TERRA RIDGE NORTH CIVIL CONSTRUCTION PLANS El Paso County, Colorado

V2_Construction Drawings Redlines.pdf Markup Summary 3-20-2023

Glenn Reese - EPC Stormwater (23)

EL PASO COUNTY DEVELOPMENT
 REPLAT TERRA RIDGE LOTS 5 & 6 W/ 11 LOTS IN
 TERRA RIDGE NORTH
 KEY MAP

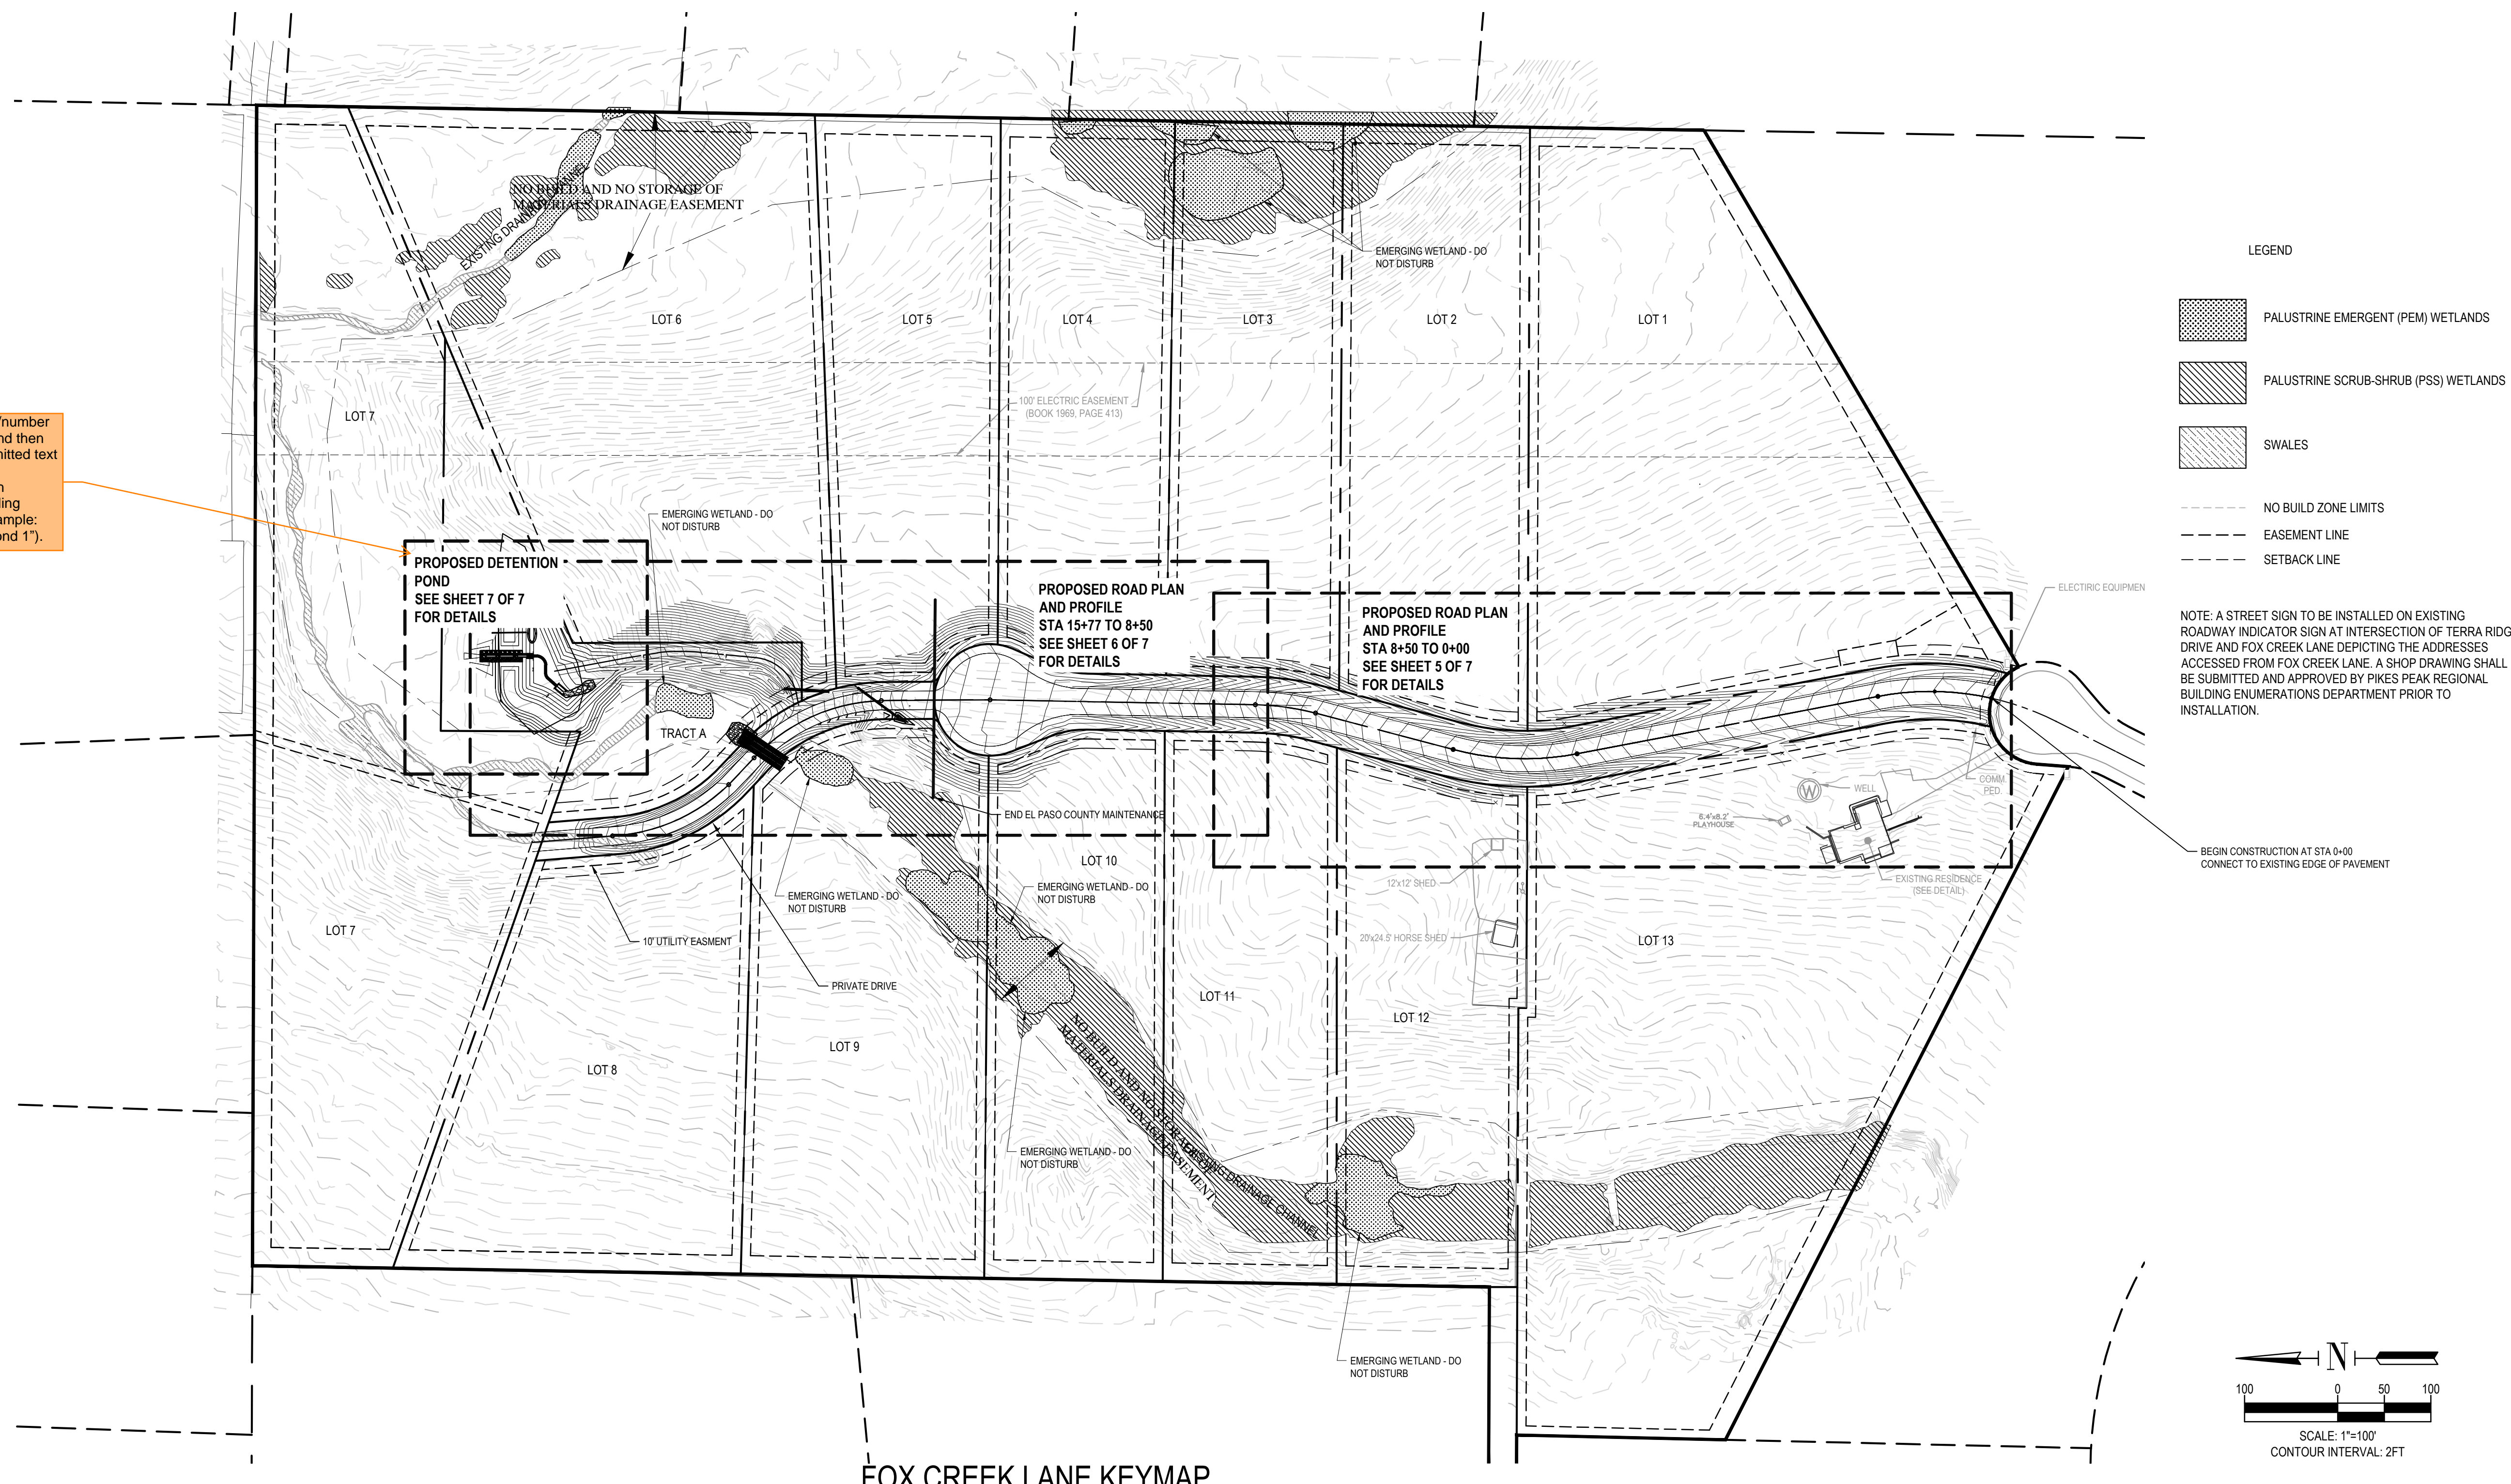
Assign a name/number to all PBMPs and then update all submitted text and drawings accordingly with consistent labeling throughout (example: "Pond A" or "Pond 1").

EL PASO COUNTY DEVELOPMENT
 REPLAT TERRA RIDGE LOTS 5 & 6 W/ 11 LOTS IN
 TERRA RIDGE NORTH
 PLAN AND PROFILE

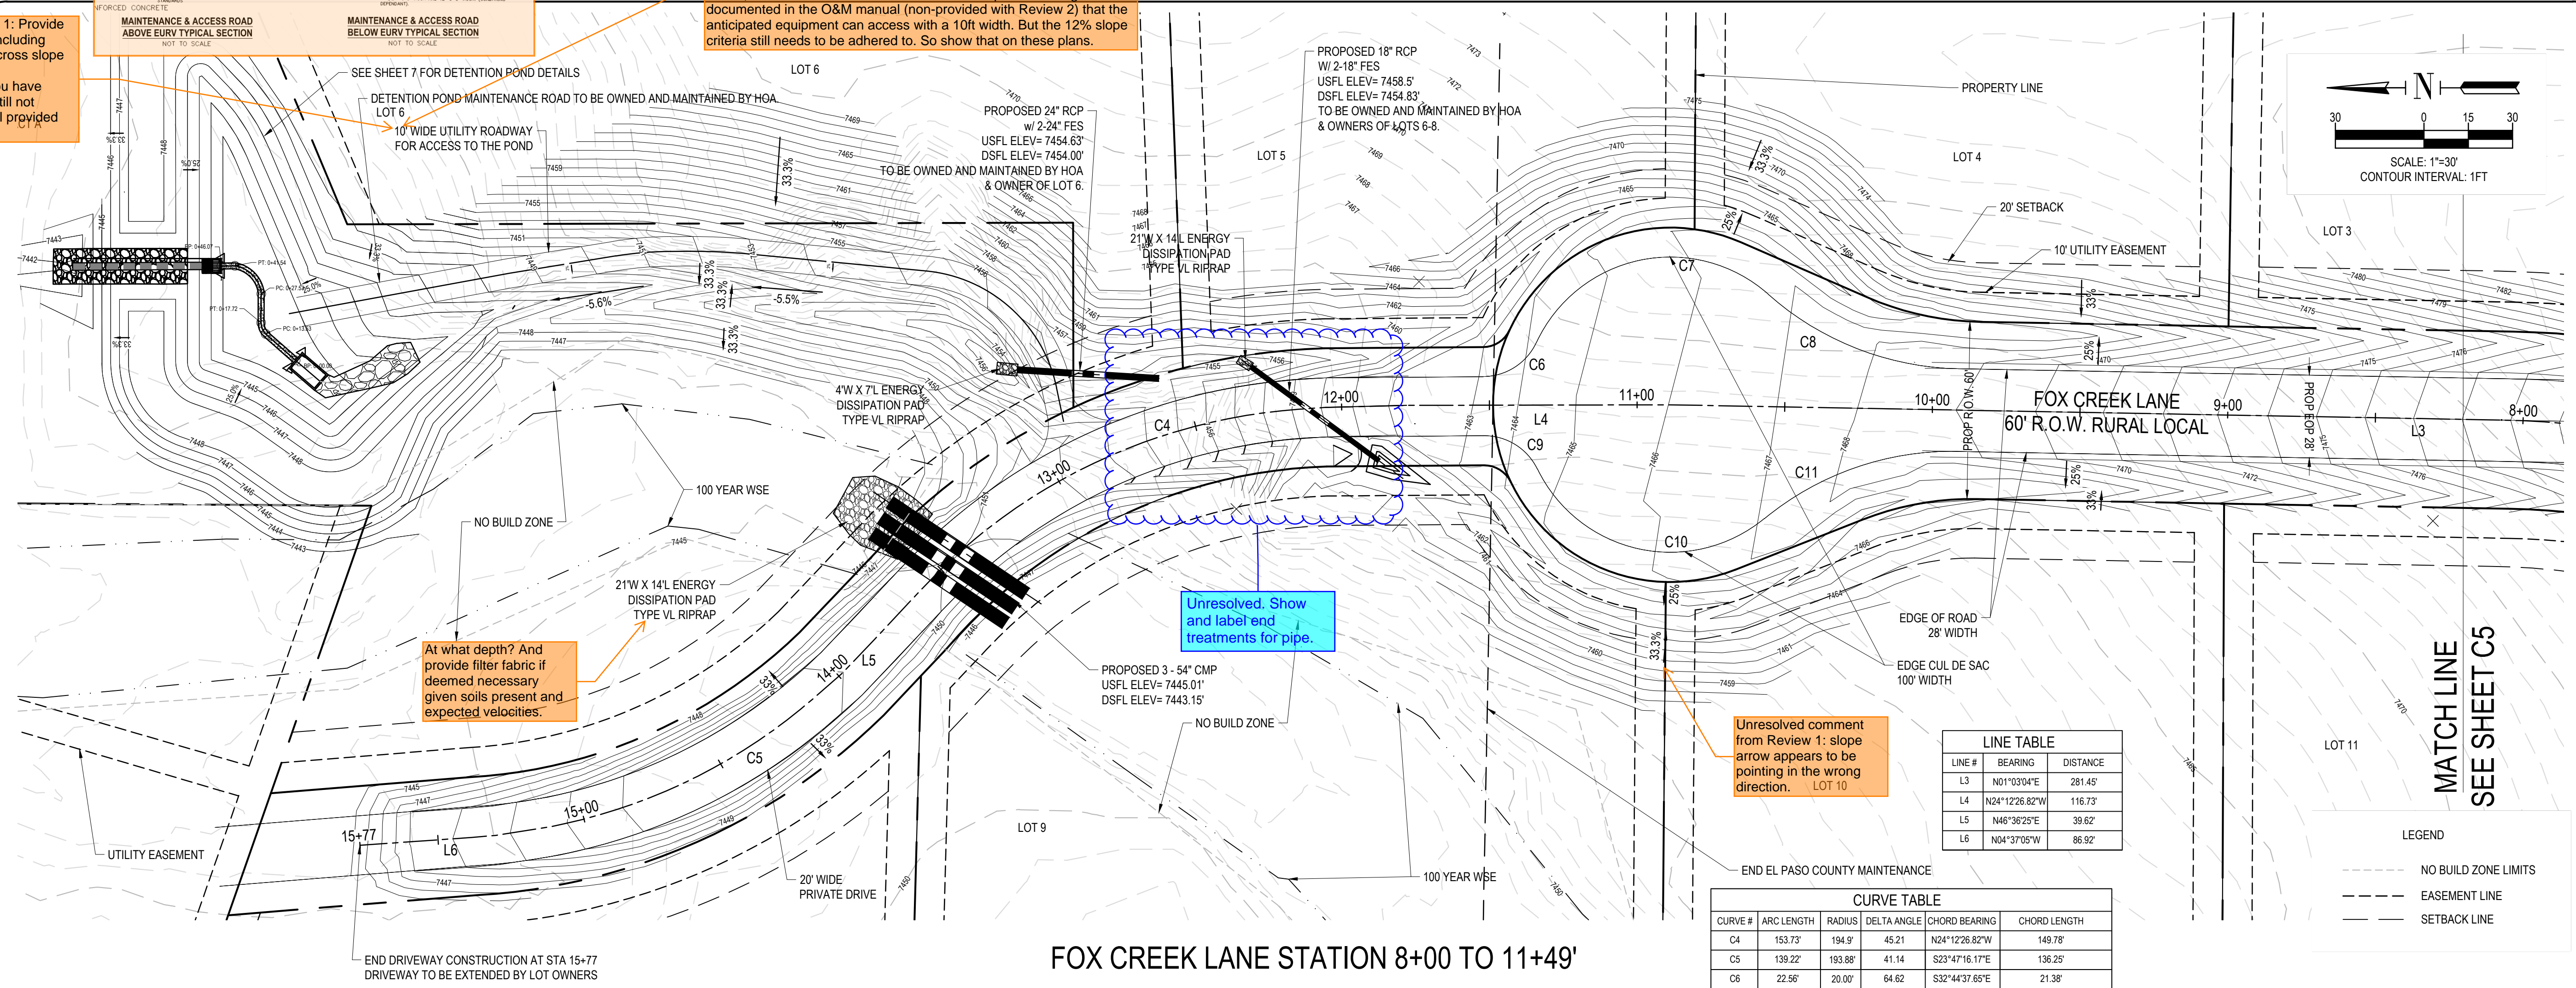
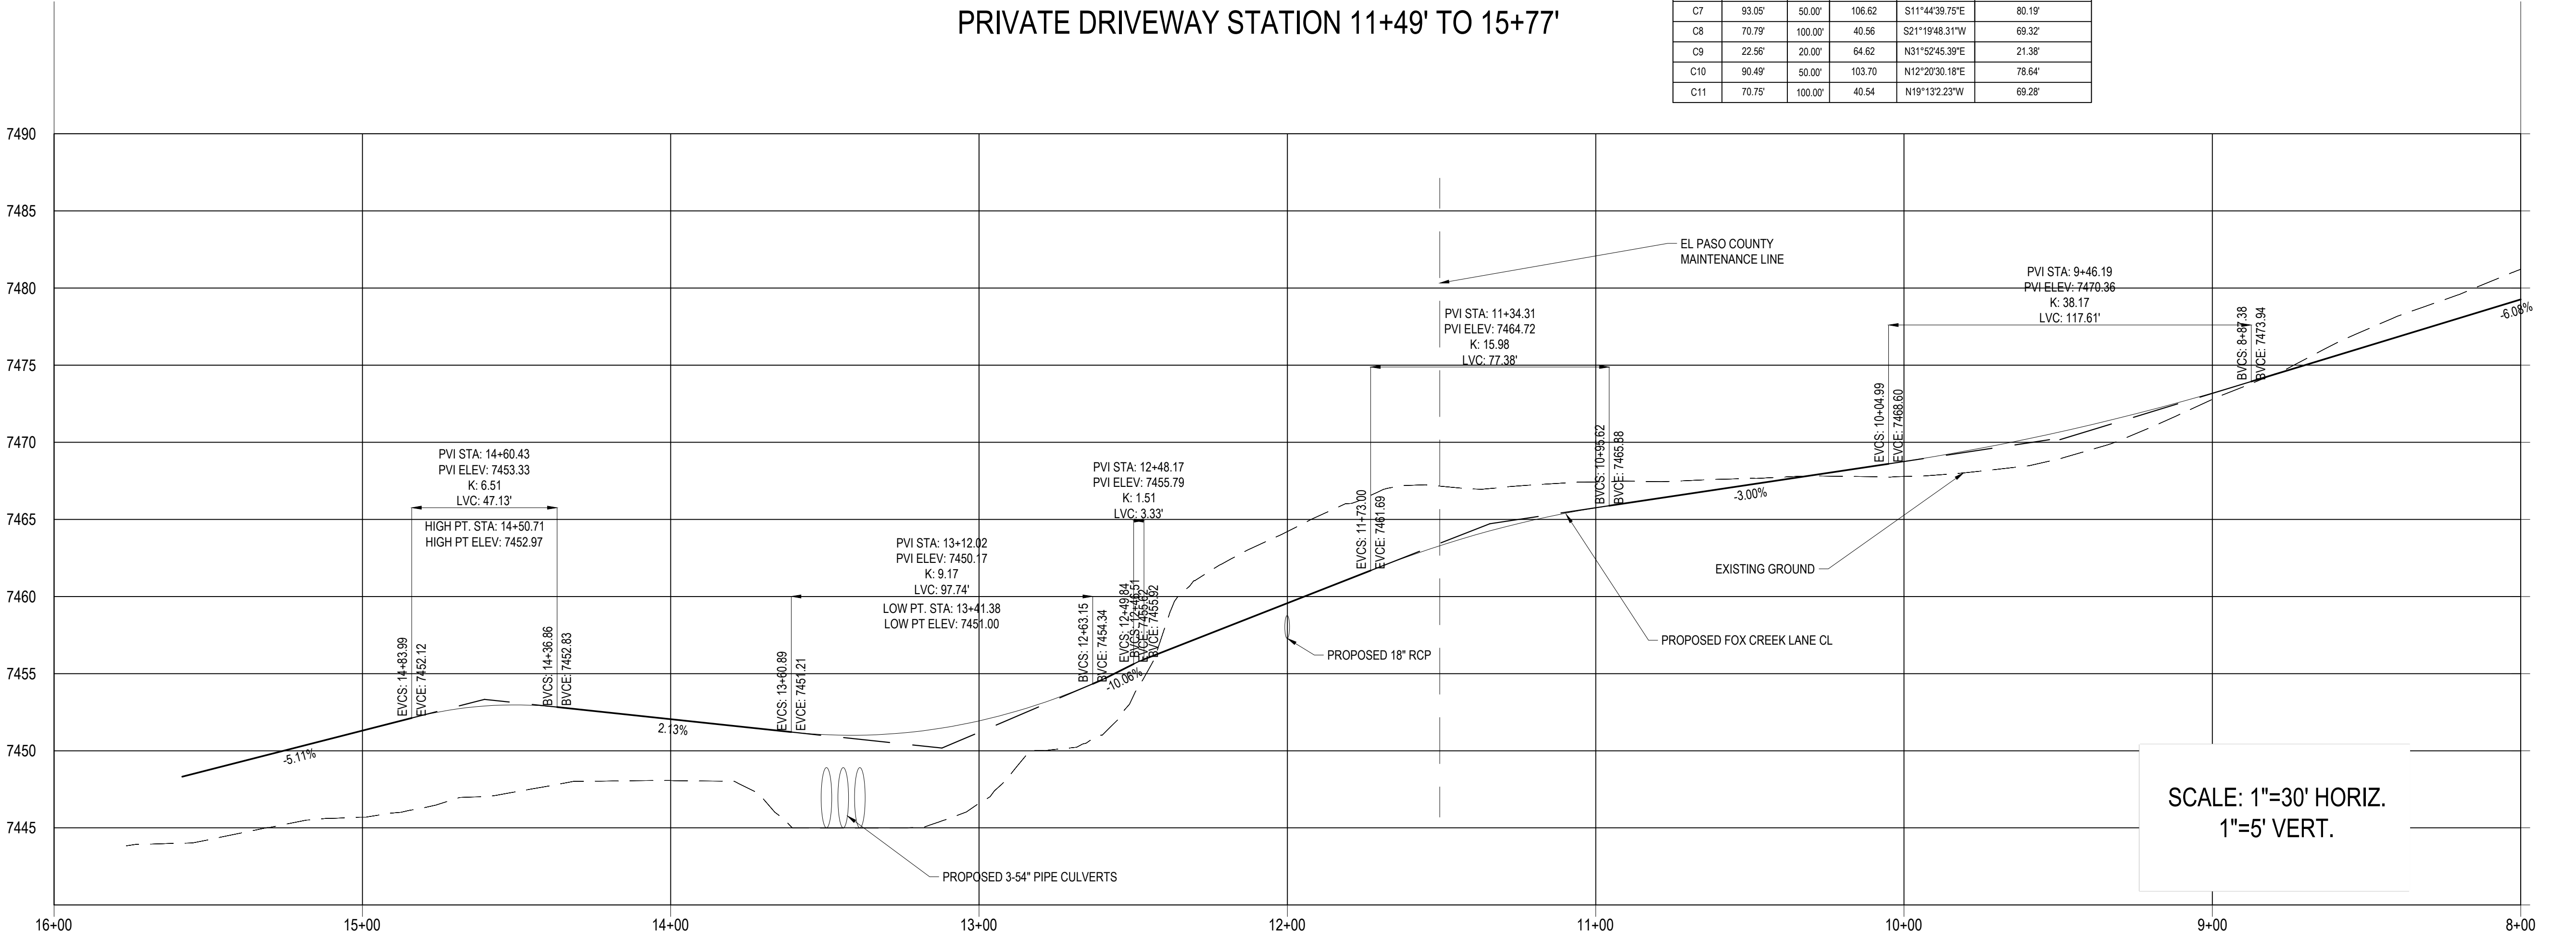
Unresolved comment from Review 1: Provide access road detail/cross section, including stone sizing and gradation. Show cross slope at 2%.

Review 2 clarification: I see that you have added 2% slope callouts. But I'm still not seeing a detail. See example detail provided above.

Unresolved comment from Review 1: -Stabilized access ramp shall be a minimum of 15ft wide and no greater than 12% slope, in accordance with DCMv1, Chap 11.2.2.

Review 2 clarification: per email discussion with Shay about this on 2/3/22, I had stated that a 10ft wide road is acceptable as long as it is documented in the O&M manual (non-provided with Review 2) that the anticipated equipment can access with a 10ft width. But the 12% slope criteria still needs to be adhered to. So show that on these plans.
